## Planning Decisions Committee Meeting

6:30 pm, Tuesday 23 June 2026

5.1. PLN23/0441.01 - 155 Johnston Street, Fitzroy.....6

<b>Property</b>	155 Johnston Street, Fitzroy
<b>Ward</b>	MacKillop
<b>Application number</b>	PLN23/0441.01
<b>Proposal</b>	Section 72 Amendment to Planning Permit PLN23/0441 for various modifications to the permit and concurrent endorsement of Condition 1 Plans
<b>Zoning &amp; Overlay/s</b>	<ul style="list-style-type: none"> <li>- Commercial 1 Zone (<b>C1Z</b>)</li> <li>- Design and Development Overlay - Schedules 10 and 36 (<b>DDO10 &amp; DDO36</b>)</li> <li>- Development Contributions Plan Overlay - Schedule 1 (<b>DCPO1</b>)</li> <li>- Environmental Audit Overlay (<b>EAO</b>)</li> <li>- Heritage Overlay Schedule 334 (<b>HO334</b>)</li> <li>- Heritage Grade: Not Contributory</li> </ul>
<b>Strategic setting</b>	High change area Neighbourhood activity centre
<b>Submissions</b>	Six (6) objections
<b>Key reasons for support</b>	<ul style="list-style-type: none"> <li>- Amended proposal generally complies with the built form requirements of the DDO and would make a positive contribution to the area</li> <li>- Largely complies with Clause 58 (subject to conditi

Figure 24 3D Render of amended development viewed from Young Street, with the location of the void above the substation circled in red (Source: FK Architects, dated 10.03.2026)

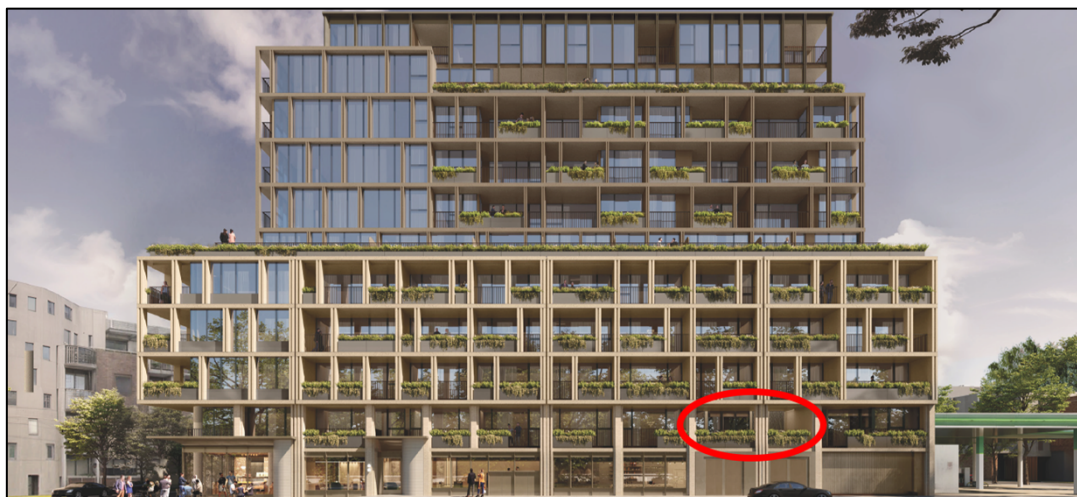
126. Council's Urban Design Unit is also not supportive of the recessed space proposed above the substation fronting Young Street as this will likely cause future maintenance issues and provides limited benefit for adjacent residents. The applicant has advised that the recess provided is a requirement associated with the substation design. Planning Officers consider that the recess is suitably integrated into the design of the overall podium presentation to Young Street (see image below).

Figure 26 Advertised plans dated 08.10.2025 showing planters along the Argyle Street façade outlined in blue (Source: FK Architects, dated 10.03.2026)

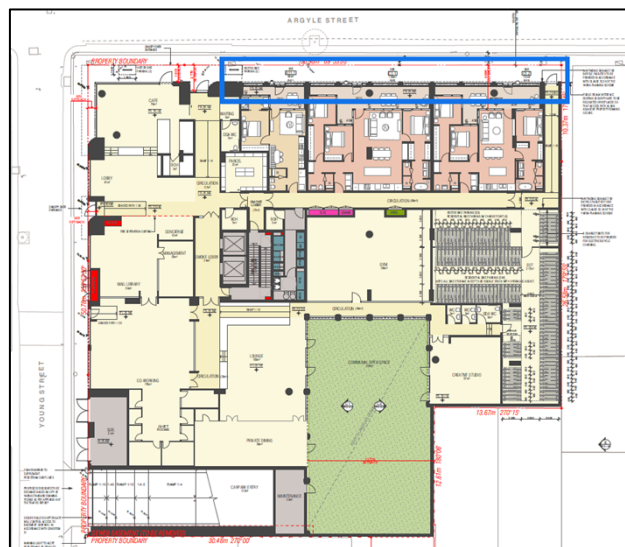
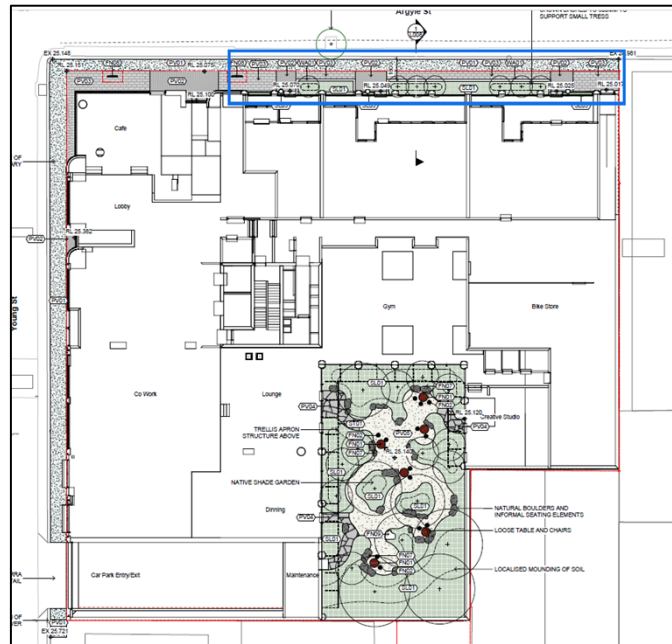
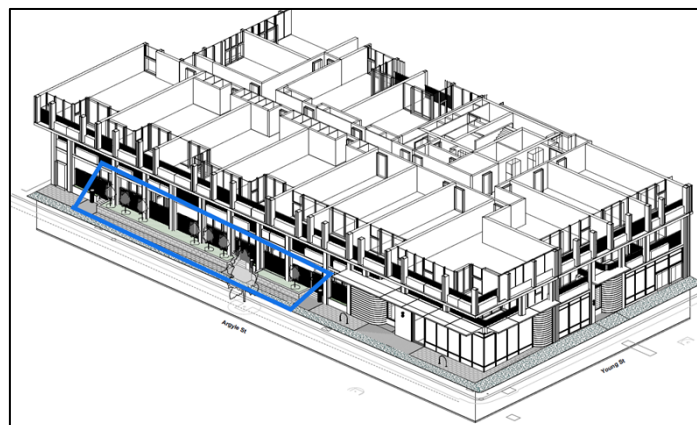
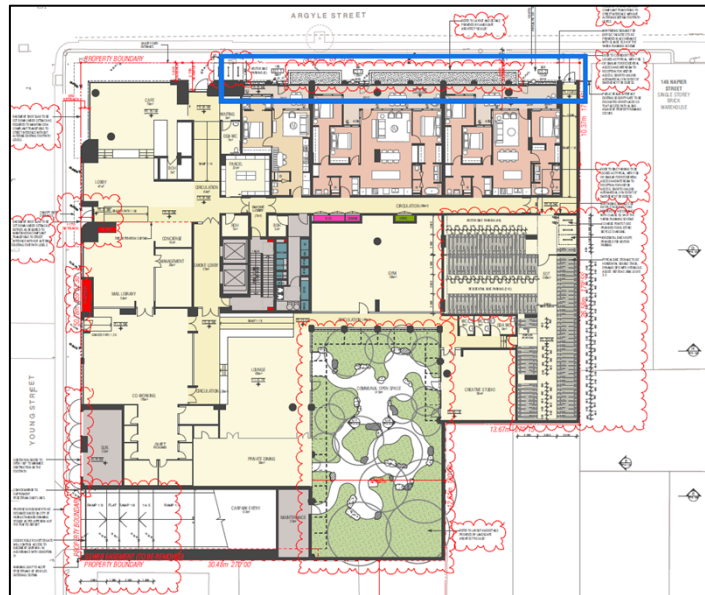
- (c) There is an inconsistency between the advertised plans and the Landscape Plan. The advertised plans (dated 08.10.2025) show landscaping between each pillar for individual dwellings fronting Argyle Street. In contrast, the Landscape Plan (dated 25.12.2025) depicts 1.2m wide raised planters encroaching into the widened footpath along Argyle Street (see images below outlining these inconsistencies). When the first S57A plans (dated 10.03.2026) were submitted, this was rectified by proposing raised planters along the Argyle Street frontage, to be consistent with the Landscape Plan. Council’s City Works – Projects and Park & Open Space Unit (PPOS) are also not supportive of the raised planters stating that these will impair usability of the setback space for pedestrians. The PPOS Unit have recommended 0.4m wide planter boxes reintroduced along the full extent of each individual ground floor terrace fronting Argyle Street. The requirements of the DDO36 states development on streets other than Johnston Street should achieve active frontage design at ground level to create a pedestrian-oriented environment and passive surveillance towards the public realm. Therefore, Planning Officers support the above comments from internal units and recommend a condition requiring the deletion of these raised planter boxes, with the landscape design reverting to that shown in the advertised plans (dated 08.10.2025). This would allow for improved passive surveillance and activate the street frontage;

- (ii) **Deletion of the raised planter boxes along the widened Argyle Street footpath, and revert the landscape design along the Argyle Street frontage to that shown in the advertised plans (dated 08.10.2025);**
